April 15, 2020

**Re: Request for Correction Under the Data Quality Act to NIST's Final Report on the Collapse of World Trade Center Building 7**

The information that is the subject of this Request is NIST's *Final Report on the Collapse of the World Trade Center Building 7* (NCSTAR 1A) and NIST's *Fire Response and Probable Collapse Sequence of World Trade Center Building 7* (NCSTAR 1-9), collectively referred to herein as the "NIST WTC 7 Report." Secondly, NIST's webpage titled *FAQs – NIST WTC 7 Investigation* (referred to herein as the "NIST WTC 7 FAQs") is also the subject of this Request. The NIST WTC 7 Report can be found at the following NIST webpage: <https://www.nist.gov/el/final-reports-nist-world-trade-center-disaster-investigation> (last visited April 14, 2020). The NIST WTC 7 FAQs can be found at the following NIST webpage: <https://www.nist.gov/topics/disaster-failure-studies/faqs-nist-wtc-7-investigation> (last visited April 14, 2020).

Figure 1: NIST's global collapse analysis at 2.5 seconds after the initiation of the east penthouse collapse laid over .1 seconds before the east penthouse collapse initiation.

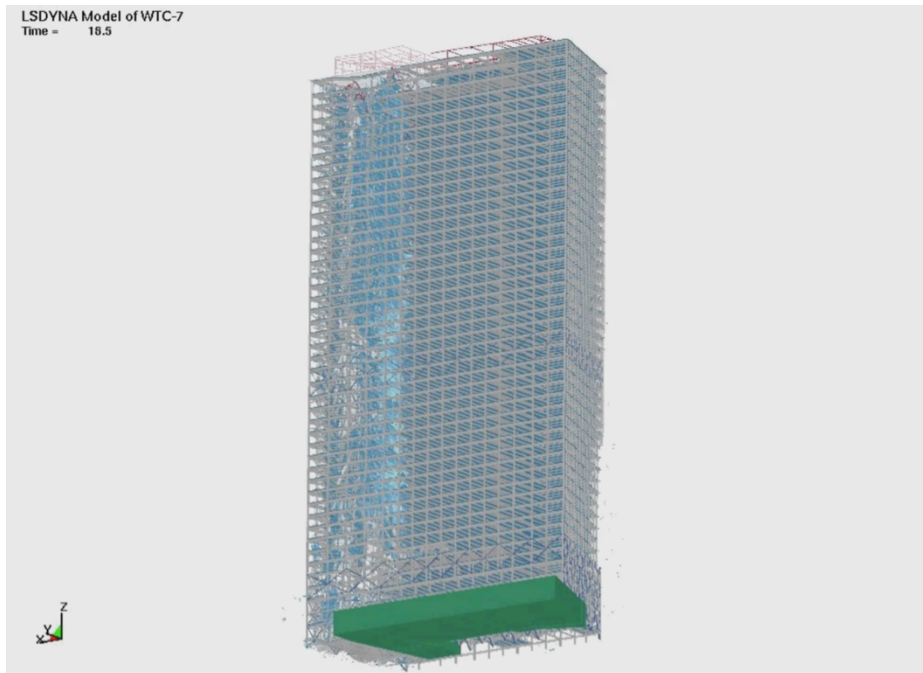
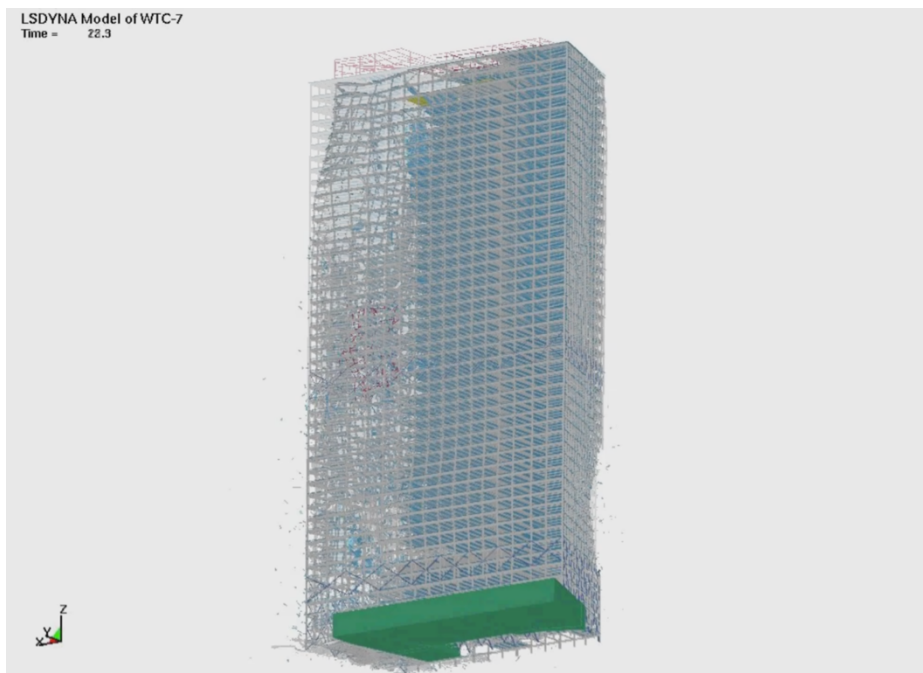
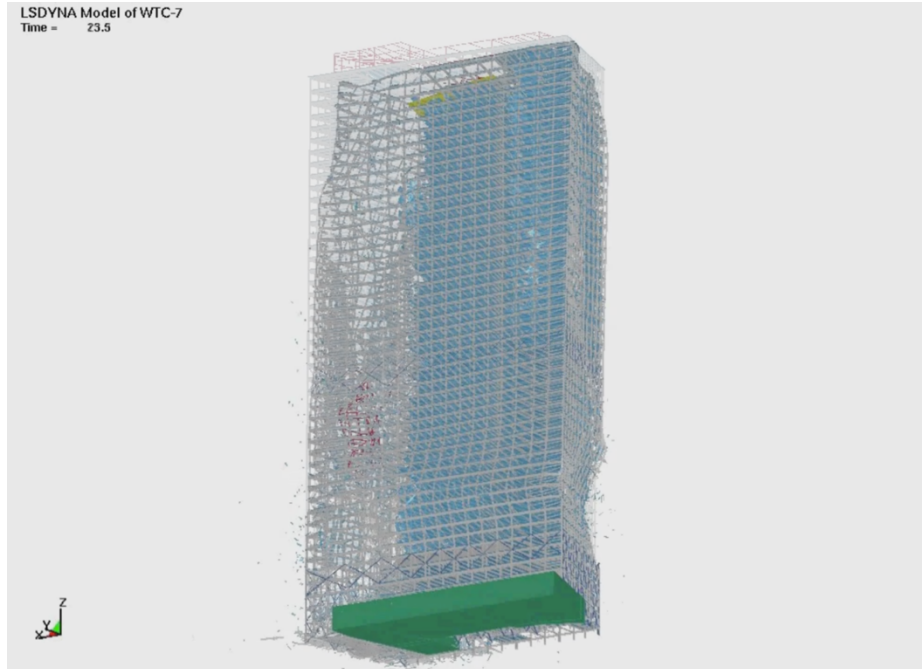
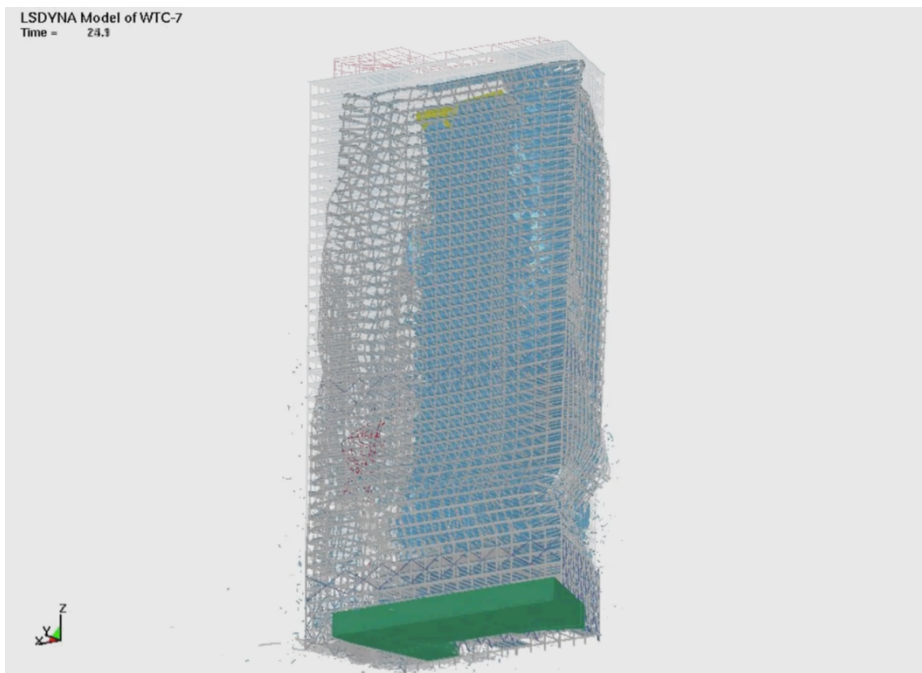
Meanwhile, as noted above, the NIST global collapse analysis predicts significant deformation of the upper exterior walls *both before and after the initiation of global collapse*. The four figures below illustrate the increasing deformation of the upper exterior walls predicted in NIST’s global collapse analysis at four different points in time by overlaying each animation frame on top of the animation frame just before the initiation of the east penthouse collapse (which is at 16 seconds in NIST’s global collapse analysis animation). 2.5 seconds is where the first deformation of the exterior appears; 6.3 seconds is the time that NIST identifies as the initiation of global collapse in its global collapse analysis; 7.5 seconds is the time examined in the figures above, when the upper exterior corners had still experienced no deformation or displacement; 8.1 seconds is the final frame in the global collapse analysis. NIST claims in NIST WTC 7 FAQ #35 that **“Only in the later stages of the animation, after the initiation of global collapse, do the upper exterior wall deformations from the NIST analysis differ from the video images.”** (Emphasis added.) That claim is false, as shown in the first two figures below.

Figure 5: Video and analysis animation at 5 seconds after initiation of east penthouse collapse.

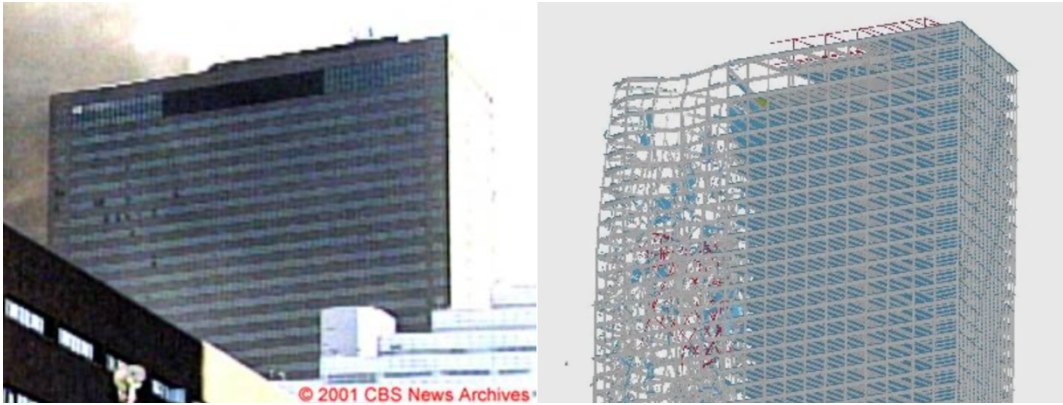
The next three figures juxtapose video of the collapse with NIST's global collapse analysis at 5 seconds, 7.5 seconds, and 8.1 seconds after the initiation of the east penthouse

collapse. The video stills are taken from Figures 5-199, 5-200, and 5-202 of NCSTAR 1-9. The global collapse analysis animation frames are cropped and scaled to approximate the scale of the video stills, and their timing aligns perfectly with the timing of the video stills.

**Figure 12–62. Exterior column buckling after initiation of global collapse with debris impact and fire-induced damage (slabs removed from view).**

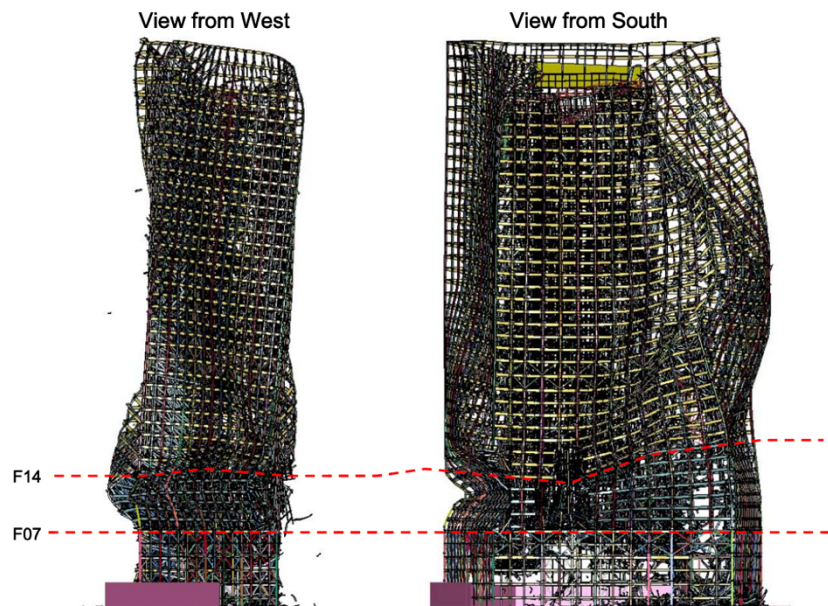
In addition to the global collapse analysis animation shown above, Figure 12-62 from NCSTAR 1-9, shown below, illustrates the significant deformation of the exterior predicted in NIST’s global collapse analysis, with the upper eastern exterior folding inward to the south dramatically, as acknowledged by NIST: “In both analyses, the eastern exterior wall deflected inward at the roof level as the structure became unsupported after the vertical collapse event.” (See NCSTAR 1A, p. 44.) However, this behavior was not observed in any videos of the collapse.

**Figure 5–205.**  
**Difference images**  
**from the Camera 3**  
**video clip showing**  
**the rotation of the**  
**northeast edge of**  
**WTC 7 during the**  
**global collapse.**  
 Times are referenced  
 to the time the east  
 penthouse began to  
 descend into the  
 building.

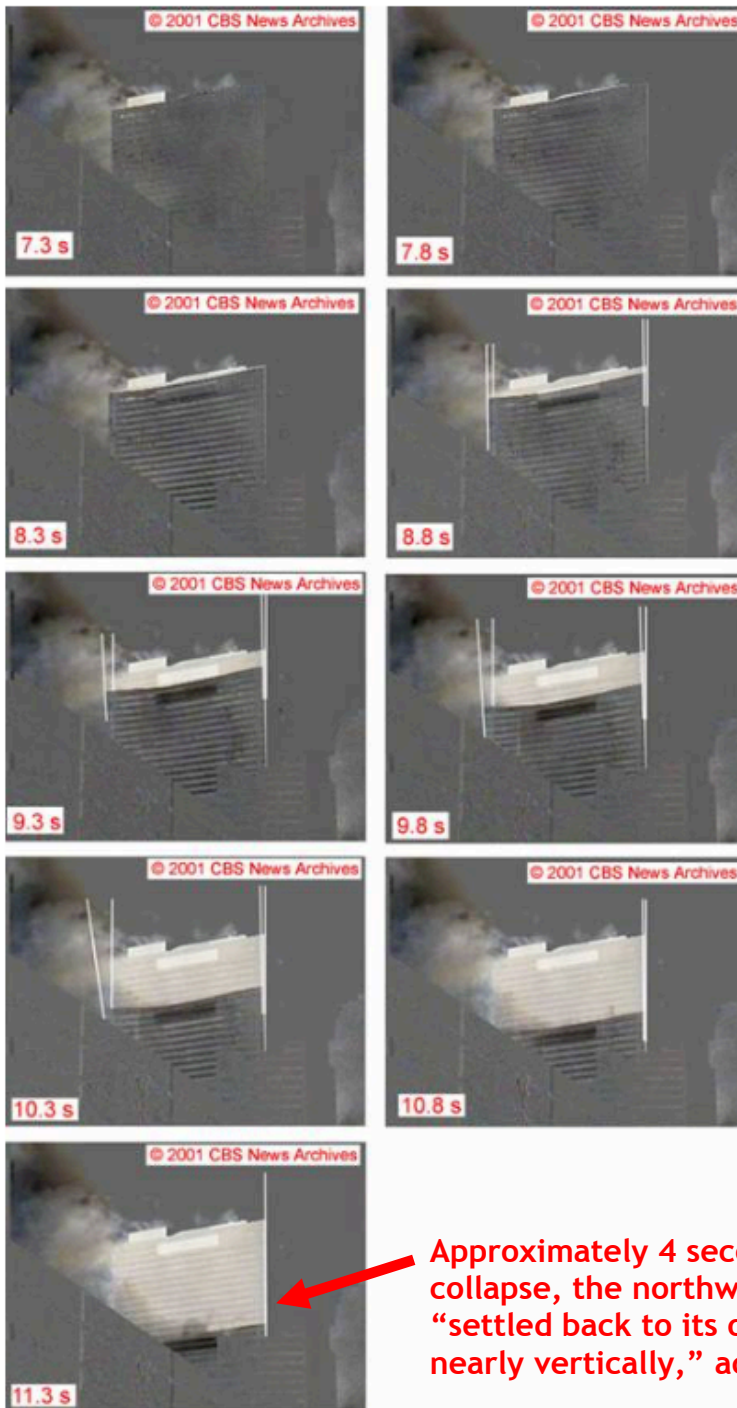
In contrast, NIST’s global collapse analysis predicts both the northeast and northwest edges of WTC 7 tipping to the south — not to the north — in a manner that appears they would not have tilted back to the north and, in the case of the northwest edge, that it would not have settled back to its original line. The southward tipping predicted in NIST’s global collapse analysis is shown below in the western view from Figure 12-62 of NCSTAR 1-9 (left) and in the overlay of the final frame from NIST’s global collapse analysis animation on top of the frame just before the initiation of the east penthouse collapse (right).

It should be noted that the illustration and animation of NIST’s global collapse analysis shown in Figure 8 below correspond approximately to the position of WTC 7 at 8.3 seconds in the video, at which point there is no tipping or tilting of the building (see “8.3 s”). It is apparent that at the rate of tipping shown in the global collapse analysis, approximately 3 seconds later the model would have shown the building tipping southward dramatically far from its original position.

Figure 8: NCSTAR 1-9 Figure 12-62 View from West (left); NIST's global collapse analysis at 8.1 seconds after east penthouse collapse initiation laid over .1 seconds before the east penthouse collapse initiation (right).

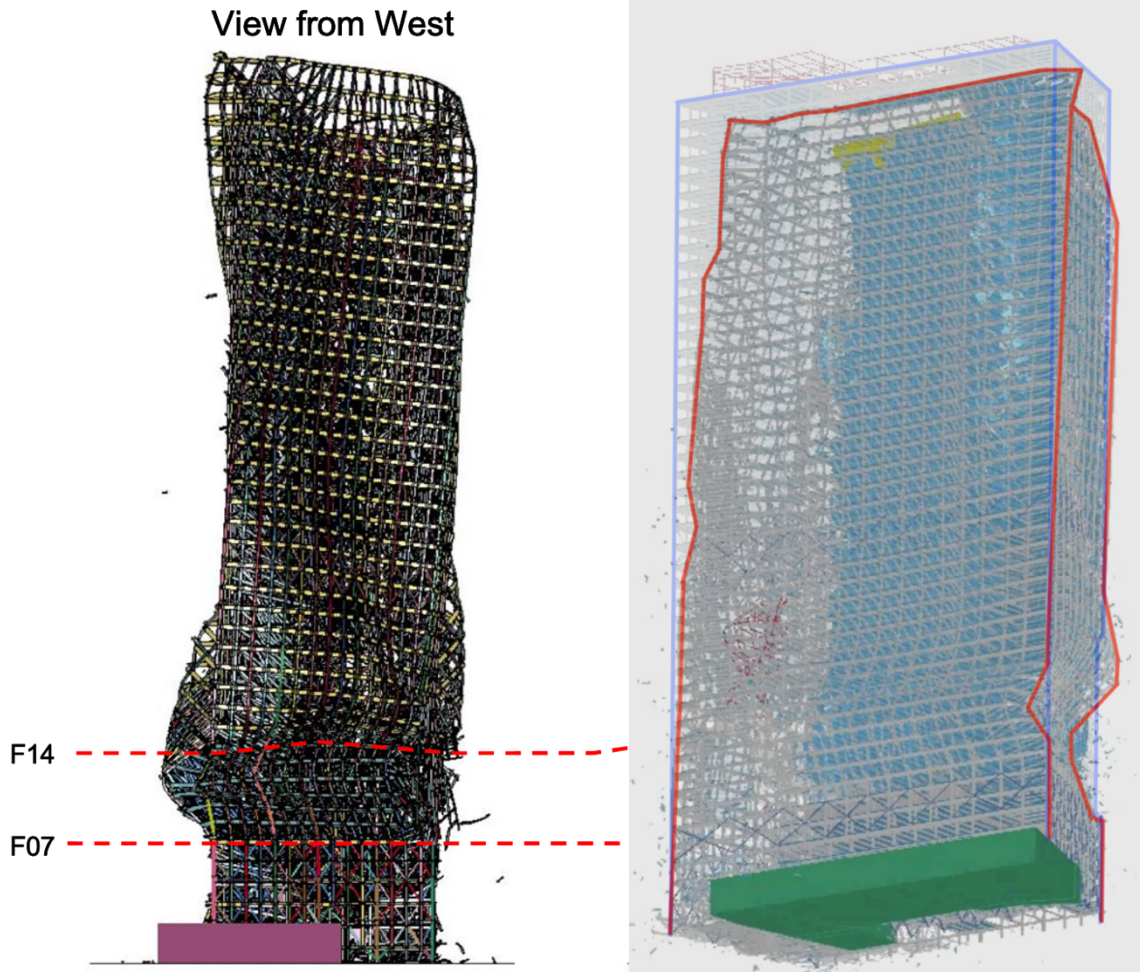
Approximately 4 seconds into the global collapse, the northwest edge had “settled back to its original line and fell nearly vertically,” according to NIST.

Figure 12-76  
Downward  
displacement of  
north face roofline  
as WTC 7 began to  
collapse.

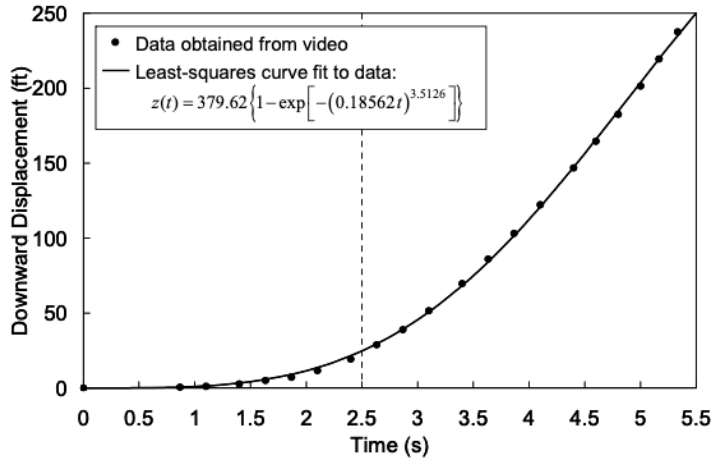
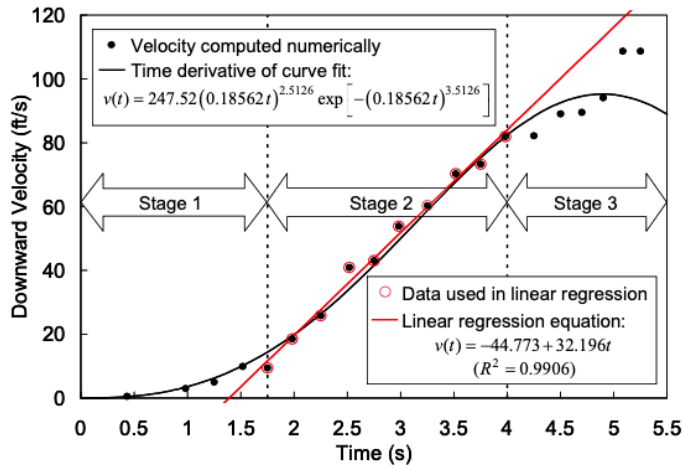
Upon closer examination, we find that NIST’s method of measuring the building’s downward motion by tracking the vertical position of a single point “near the center of the roofline” oversimplifies and misrepresents the actual downward motion of the entire roofline.

### a) **Revise the NIST WTC 7 Report to Reflect that the North Face Roofline Underwent a Sudden Transition to Free Fall**

First, NIST must revise the NIST WTC 7 Report to reflect that, based on new measurement of video footage that is level with the roofline, the north face roofline of WTC 7 underwent a sudden transition to free fall, with the middle of the roofline dropping approximately half a meter, then stopping, and then dropping approximately 1 meter further, before entering into free fall along with the entire roofline.

Figure 9: Left: Displacement versus time of north face roofline at northwest corner, middle, and northeast corner. Right: Velocity versus time of north face roofline at northwest corner, middle, and northeast corner.

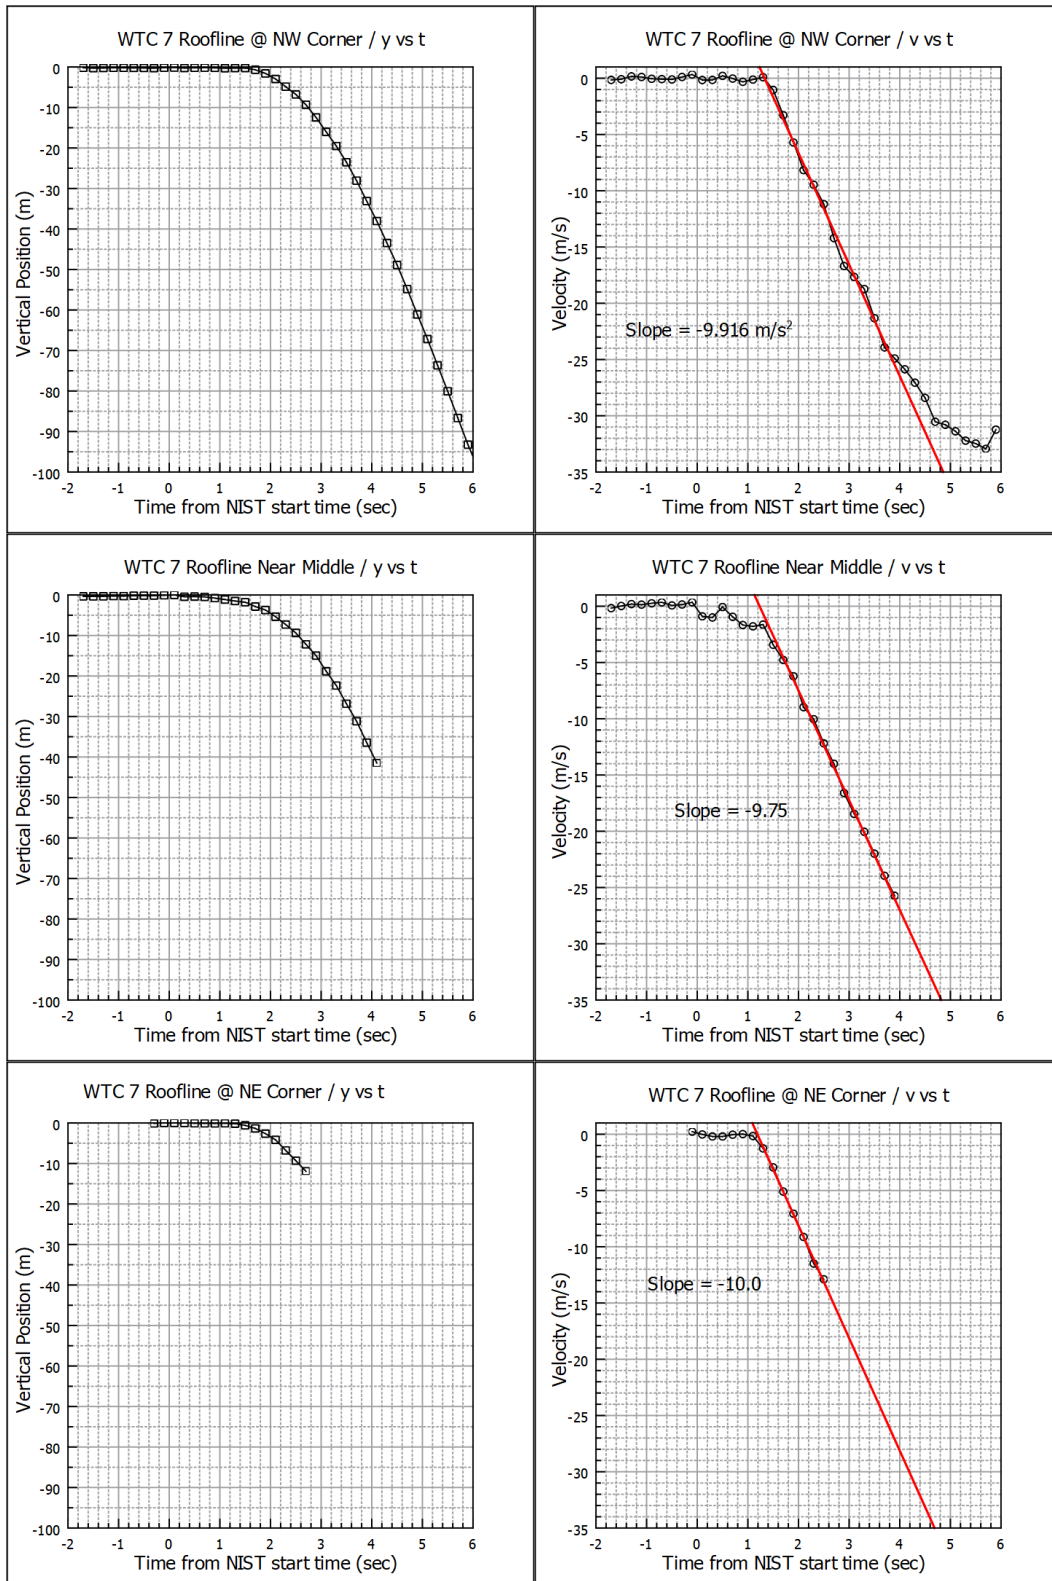
Careful measurement by physicist and researcher David Chandler using the video that NIST labeled as Camera 2, which has a line of sight approximately level with the roofline, shows that a point near the center of the roofline did indeed begin to move downward at about 6.9 seconds after the east penthouse collapse initiation, but that the northeast and northwest corners of the roofline did not begin to move downward until about 8.2 seconds after the east penthouse collapse initiation. Chandler’s measurement is corroborated by Figure 5-201 of NCSTAR 1-9 above, which shows a slight displacement at the middle of the roofline and zero displacement of the upper exterior corners 7.5 seconds after the east penthouse collapse initiation. Figure 9 below presents the downward displacement and downward velocity of the north face roofline versus time at the northwest corner, middle, and northeast corner of the roofline. In the time axis, zero represents NIST’s initiation of global collapse, which is 6.9 seconds after the east penthouse collapse initiation.

According to Chandler’s measurements, between 6.9 seconds and 8.2 seconds, the point near the center of the roofline dropped approximately half a meter, then stopped, and then dropped approximately 1 meter further, while the northeast and northwest corners remained stationary. **Then, at 8.2 seconds, within a tenth of a second, all three points along the roofline suddenly began descending uniformly in free fall. While the northeast corner became difficult to track partway into the descent because of smoke, the measurements indicate that the middle of the roofline and the northwest corner stayed in free fall for approximately 2.5 seconds.**

**Figure 8–5. Global collapse of WTC 7 begins about seven seconds after the onset of collapse of the east penthouse.**

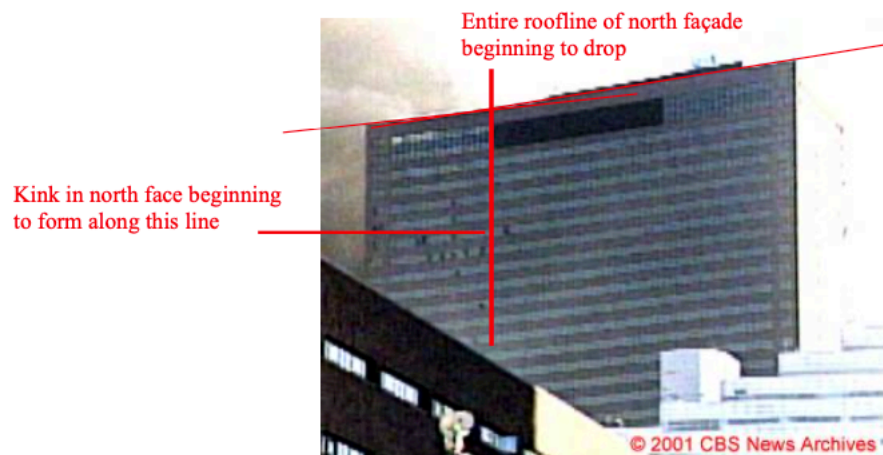
Therefore, NIST’s “Stage 1” mischaracterizes the downward motion in three important ways: (1) It overstates by approximately half a second the period of time that the middle of the roofline experienced a “slow descent” before entering free fall, claiming that this period lasted 1.75 seconds when it was closer to 1.3 seconds; (2) It wrongly portrays the displacement of the middle of roofline during this 1.3 seconds as a smooth transition to free fall, when in fact it dropped approximately half a meter, stopped, and then dropped approximately 1 meter, before suddenly entering free fall; (3) Most importantly, it generalizes the downward motion of the middle of the roofline to represent the downward motion of the entire roofline, when in fact the northeast and northwest corners did not descend at all from 6.9 seconds to 8.2 seconds, and their transition from stasis to free fall was instantaneous and simultaneous — an observation that is inconsistent with NIST’s claim that “[t]he south and west exterior columns buckled first, followed by the north and east face columns.” (See NCSTAR 1-9, p. 586.) NIST’s generalization of the entire roofline’s behavior is exemplified in Figure 8-5 of NCSTAR 1-9, shown below, in which NIST states, “**Entire roofline** of north façade beginning to drop” “**about seven seconds** after the onset of collapse of the east penthouse” (emphasis added) (see NCSTAR 1-9, p. 327):

**Thus, the downward motion of WTC 7’s north face roofline at the onset of global collapse is more accurately characterized as a sudden transition to free fall.** Prior to the initiation of the entire roofline’s free fall, the middle of the roofline dropped approximately half a meter, then stopped, and then dropped approximately 1 meter further, before entering into free fall along with the entire roofline.

Figure 4.2 Columns 79, 80, and 81 are removed from Floor 6 to Floor 13. The key to the right is expressed in inches of movement. The building tilts to the east almost 10 inches. The penthouse does not collapse.

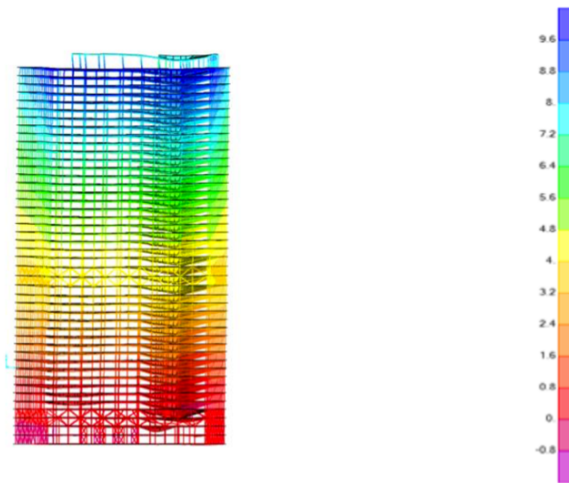
First, the UAF team found that the collapse of the east penthouse was most accurately predicted by simulating the failure of Columns 79, 80, and 81 from the 45<sup>th</sup> floor up to the penthouse. This failure mechanism caused the east penthouse to collapse into the building while also causing minimal movement of the exterior. In contrast, the UAF team found that as the failure of Columns 79, 80, and 81 was simulated progressively lower in the building, the east penthouse was *less likely* to collapse into the building, because the intact portions of Columns 79, 80, and 81 above where the columns failed would still support the penthouse. At the same time, there would be greater movement of the exterior the further down the column failures were simulated. Figures 4.2 and 4.7 of the UAF Report below illustrate these phenomena. Specifically, Figure 4.2 shows the results of removing Columns 79, 80, 81 from Floor 6 to Floor 13, which is approximately where these columns buckled in NIST’s Probable Collapse Sequence. (See UAF Report, p. 96, p. 99.)
